SUBJECT: CLARIFICATION OF SEVERAL NRC REQUESTS FOR ADDITIONAL
INFORMATION ON CALVERT CLIFFS NUCLEAR POWER PLANT LICENSE
RENEWAL APPLICATION SUBMITTED BY THE BALTIMORE GAS AND
ELECTRIC COMPANY (TAC NOS. MA1445, MA1446, M99214, M99587,
M99588, M99206, M98835, M98837, AND M99181)

**BGE REQUESTS FOR CLARIFICATION
ON
USNRC REQUESTS FOR ADDITIONAL INFORMATION**

**Clarification on Staff Requests for Additional Information
Regarding Baltimore Gas and Electric's Application for License Renewal
For the Calvert Cliffs Nuclear Power Plants Units 1 & 2**

Figure J-R curve data for irradiated stainless steel for a fluence of $8 \times 10^{20} \text{ n/cm}^2$ (Ref. 2).

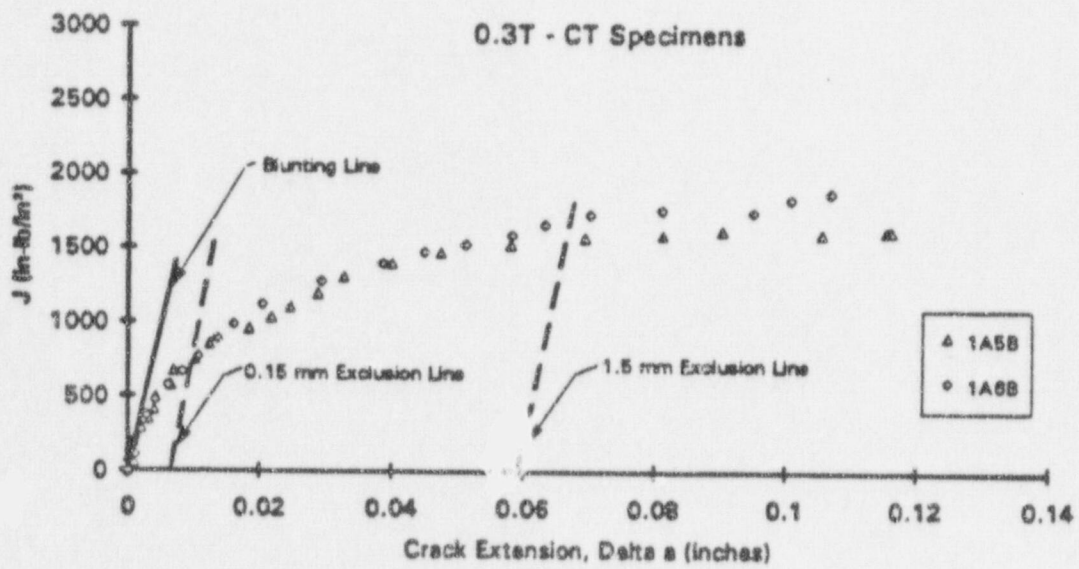
From Reference 2, J-integral resistance or J-R curve data are reported for two samples fabricated from core shroud material removed from an overseas BWR (see the attached figure). The fluence for these samples is reported in Ref. 2 as 8×10^{20} n/cm².

Reconciliation of the J_{Jc} from Reference 1 with the J-R curve trends from Reference 2 (through scaling of the J levels in the J-R curves) can provide one estimate of the fracture toughness of highly irradiated austenitic stainless steel.

Provide any other fracture toughness data used in this evaluation.
